Technical Statement for Amendment #2 to Construction Permit Modification Application:

**KAZN-TV Licensee LLC
KHIZ-DT
Channel 44
Barstow, CA**

Distributed Transmission System (DTS) Operation Under CP Modification in File No. BMPCDT-20090601AAG

Figure 2 — KHIZ DTS Network Predicted Noise-Limited Contours & Relocated Largest Station Circle

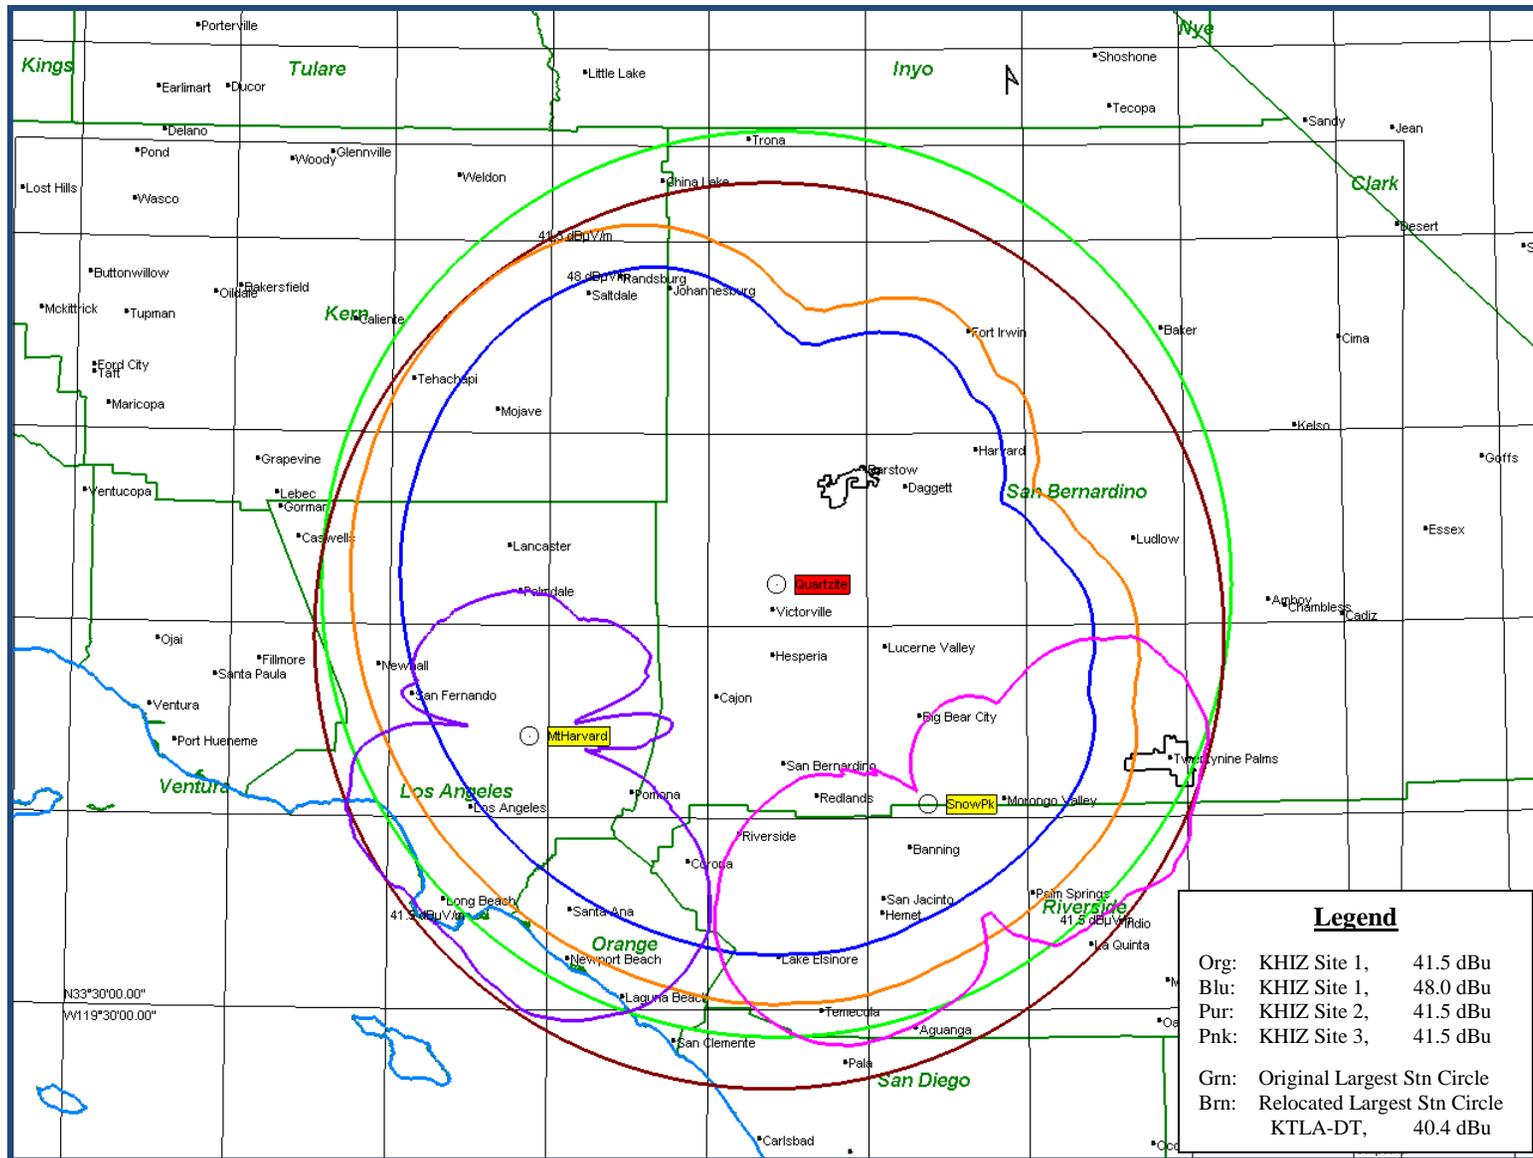
A plot of the PNLCs⁵ of the various transmitters, using the amended elevation patterns, is provided in Figure 2. Since the main, Quartzite Mountain transmitter facility authorized by the outstanding construction permit (herein, DTS Site 1) already covers the entire authorized service area of the station,⁶ the provisions of §73.626(f)(1) are met by that facility alone. By virtue of the overlap of the contours of the three transmitters, they are contiguous, thereby meeting the requirements of §73.626(f)(3). Also shown in Figure 2 is the 48 dBu contour of the DTS Site 1 facility, which can be seen to encompass the principal community of Barstow, CA. There are no major obstructions in the path over the principal community; thus, the requirements of §73.625(a) and correspondingly of §73.626(f)(4) also are met by the DTS Site 1 transmitter alone. All three transmitters in the proposed DTS network are located within the KHIZ authorized service area, consequently meeting the requirements of §73.626(f)(6).

The original Reference Point (34-36-34N, 117-17-11W) is the location of the Site 1 transmitter at Quartzite Mtn, which is the Reference Point established in the DTV Table of Allotments for KHIZ-DT. The Reference Point proposed in this amendment (34-28-30N, 117-18-30W) is situated approximately 15 km south-southeast of the Site 1 transmitter. It results in a significant increase in the population contained within the Largest Station Circle, from a population of 15,248,823 within the original circle to a population of 15,621,979 within the circle of the current proposal – over 373,000 more. At the same time, the Largest Station Circle produced from the relocated Reference Point fully encompasses the contour authorized to KHIZ-DT in its construction permit in File No. BPCDT-20080403ABK, as required for changes in Reference Points by the DTS R&O: “Such changes in reference points are subject to a station showing that the resulting service area circle fully encompasses the station’s authorized service area.”¹² This can be seen in Figure 2, where the Largest Station Circle centered on the relocated Reference Point is shown in brown and the authorized contour is shown in orange.¹³

As further can be seen in Figure 2, there are two minor areas where the contours of the gap filler transmitters extend beyond the area of the relocated Largest Station Circle by small amounts. Both of these areas are over the Pacific Ocean or desert and therefore should not be treated as extensions of the service areas of the gap fillers. Specifically, unlike the original application, there are no extensions from the Site 2 transmitter beyond the Largest Station Circle over land and only a very small extension of less than 1 km, to the southwest of Site 2, having an area of less than 5 km², over the Santa Monica Bay of

the Pacific Ocean. From the Site 3 gap filler, there is a crescent-shaped extension from 80 to 112 degrees relative to Site 3, having a maximum extension of less than 4½ km.

Evaluation of the extension areas shows that the single projection from Site 2 beyond the Largest Station Circle includes about 4.669 km². Because it is located totally over the ocean, there is no population associated with the Site 2 extension. The projection from Site 3 covers about 117 km², but it is over desert and has a population of only 39 people, despite its size. Population counts are based on the 2000 U.S. Census. To put these values into context, the total area of the projections (including the projection over water) represents about 0.2 percent of the area of the Largest Station Circle, but their population represents only about 0.00025 percent of the population of the relocated Largest Station Circle. Thus, the area of the projections is *de minimis* and the population negligible and only incidental to providing service to the major populations that are contained within the PNLCS of the gap-filler transmitters.

Figure 9a — DTS Site 2 Antenna Azimuth Relative Field Values

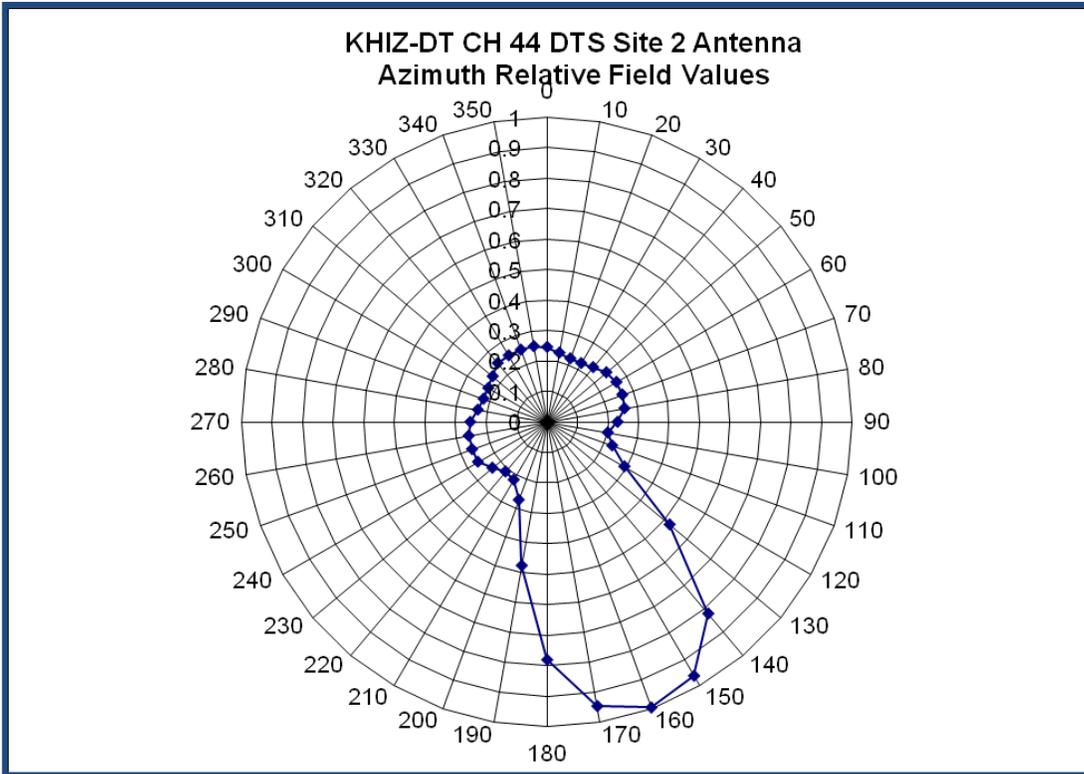
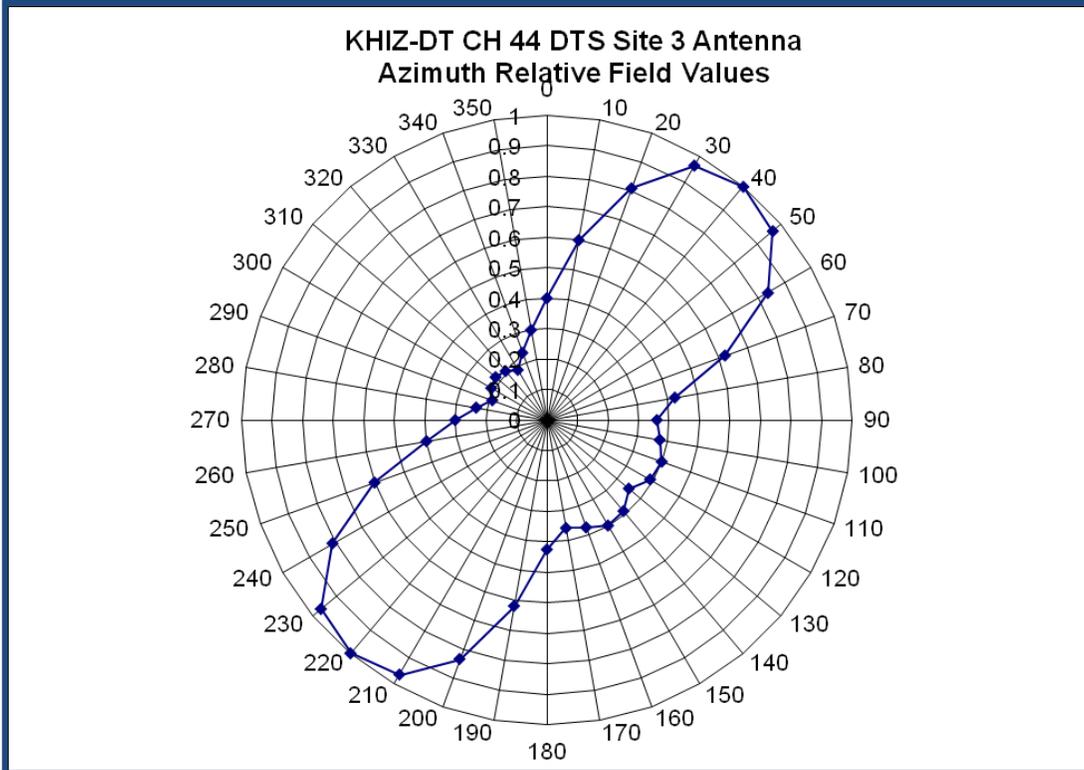
Plots of the DTS Sites 2 and 3 antenna azimuthal radiation patterns in relative field values are included as Figures 9a and 9b. The azimuthal power patterns expressed in decibels relative to 1 kW (dBk), at the depression angles having maximum power (3.6 and 3.3 degrees depression, respectively), are plotted in Figures 10a and 10b. The tabulated azimuthal field and power values are given in Figures 11a and 11b. The elevation radiation patterns in relative field values are included as Figures 12a and 12b. The elevation power patterns expressed in decibels relative to 1 kW (dBk), in the azimuthal directions having maximum power, are plotted in Figures 13a and 13b. The tabulated elevation field and power values are given in Figures 14a and 14b. All of these plots and tables are prior to application of mechanical beam tilt and therefore do not incorporate its effects, which are fully expressed in the data of the elevation patterns placed on file in the online application. The elevation pattern data for each antenna has been uploaded to the CDBS Electronic Filing System (EFS) web site in array form in Office Open XML

Figure 12a — DTS Site 2 Antenna Elevation Relative Field Values

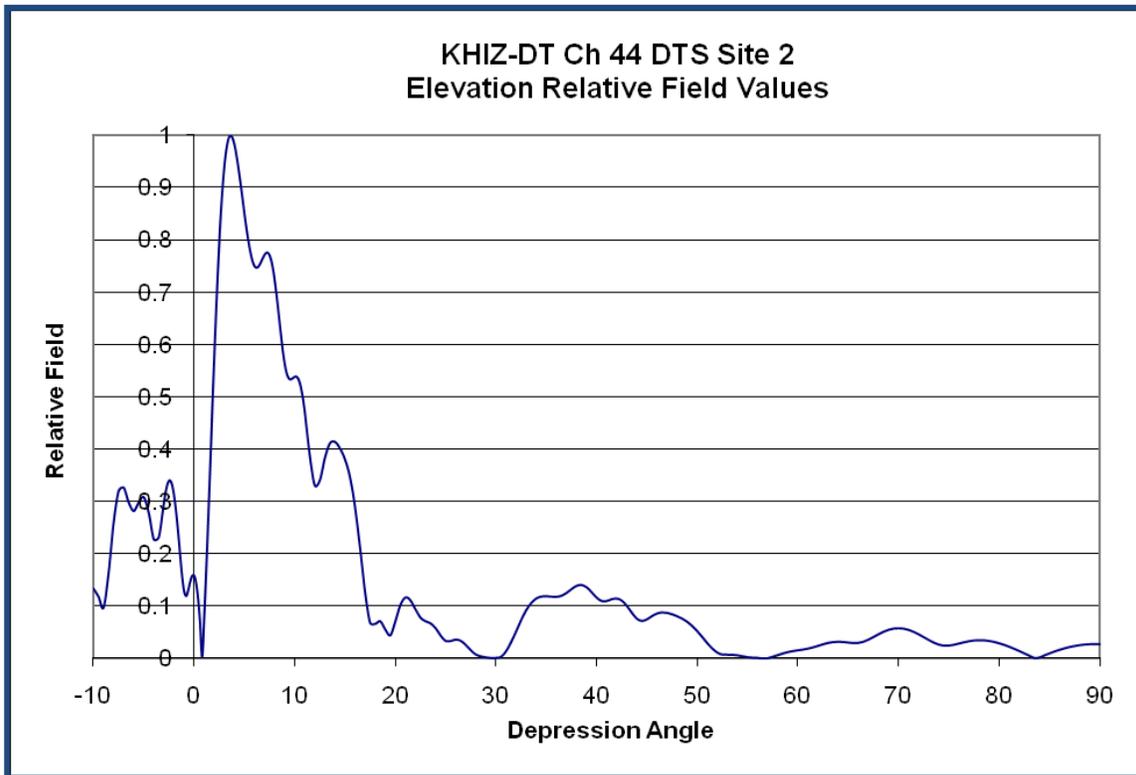
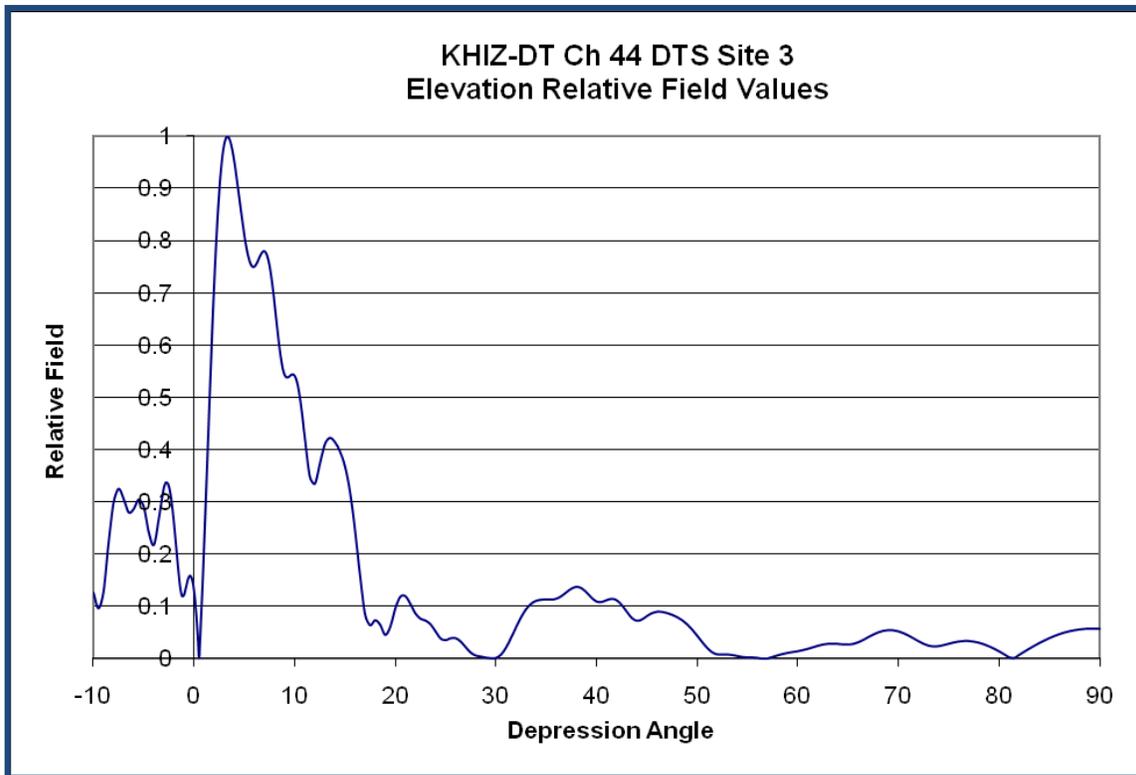
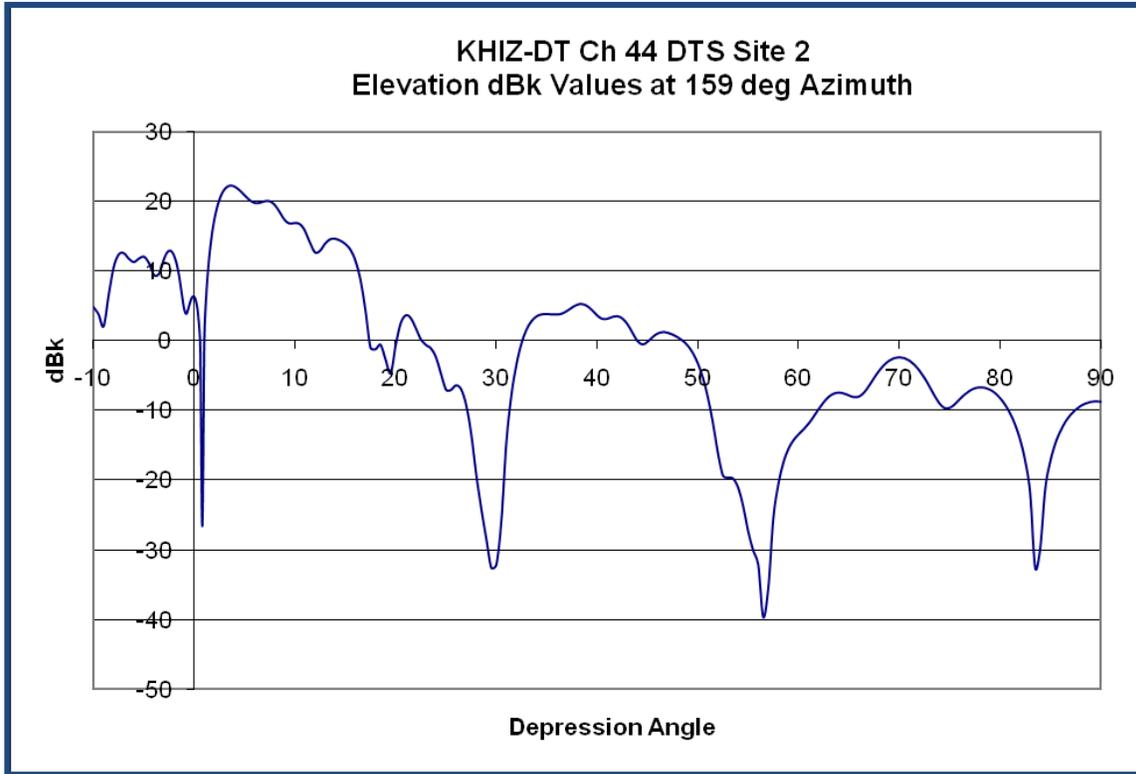
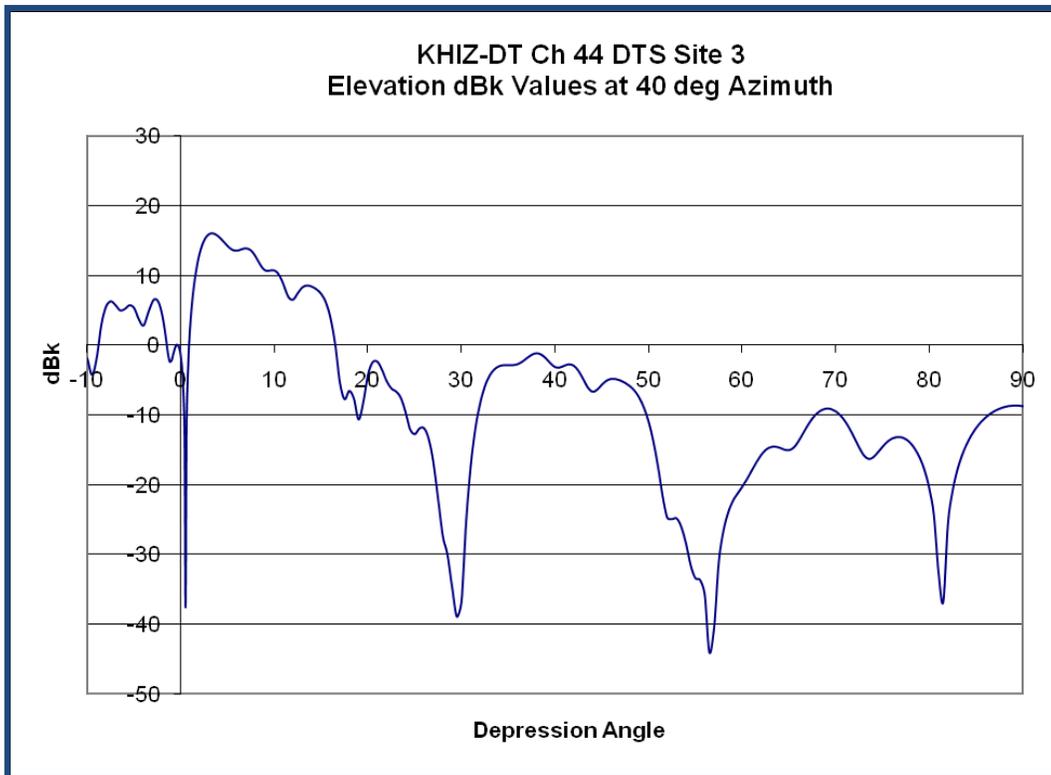
The essential elevation pattern design of the antennas for DTS Sites 2 and 3 is somewhat unusual. It includes main beams at depression angles of 3.6 and 3.3 degrees, with a rapid fall-off of relative field values above the main beams to deep nulls at depression angles of 0.8 and 0.5 degrees, respectively. The nulls serve two purposes: They help to control the locations of the contours while permitting stronger field strengths to be delivered within the service areas, and they help in controlling interference to stations in neighboring markets. The latter consideration is significant in the discussion below on Border Issues. The elevation pattern design also includes a relatively broad peak and significant power levels to depression angles of approximately 17 degrees, thereby providing strong signals to the areas below the mountains on which the gap-filler transmitters are situated.

Elevation power gain of the antenna design for DTS Site 2 is 8.53 (9.31 dBd) at the beam maximum (3.6 degrees below horizontal), less than 0.001 (−30 dBd) at the null above the main beam (0.8 degrees below horizontal), and 0.16 (−7.97 dBd) in the horizontal plane. The azimuth power gain is 5.70 (7.56 dB), yielding a total power gain in the main beam of 48.64 (16.87 dBd) and of 0.91 (−0.41 dBd) in the horizontal plane. All plane and depression angle values are with respect to the antenna axis prior to the effects of any mechanical beam tilt.

Equivalent characteristics for the DTS Site 3 antenna are elevation power gain of 8.57 (9.33 dBd) at the beam maximum (3.3 degrees below horizontal), less than 0.001 (−30 dBd) at the null above the main beam (0.5 degrees below horizontal), and 0.145 (−8.38 dBd) in the horizontal plane. The azimuth power gain is 2.88 (4.59 dB), yielding a total power gain in the main beam of 24.89 (13.96 dBd) and of 0.418 (−3.79 dBd) in the horizontal plane. All plane and depression angle values are with respect to the antenna axis prior to the effects of any mechanical beam tilt. Because of the mechanical beam tilt applied to this antenna, effective radiated power toward the radio horizon is an inappropriate parameter for this antenna and therefore is not provided.
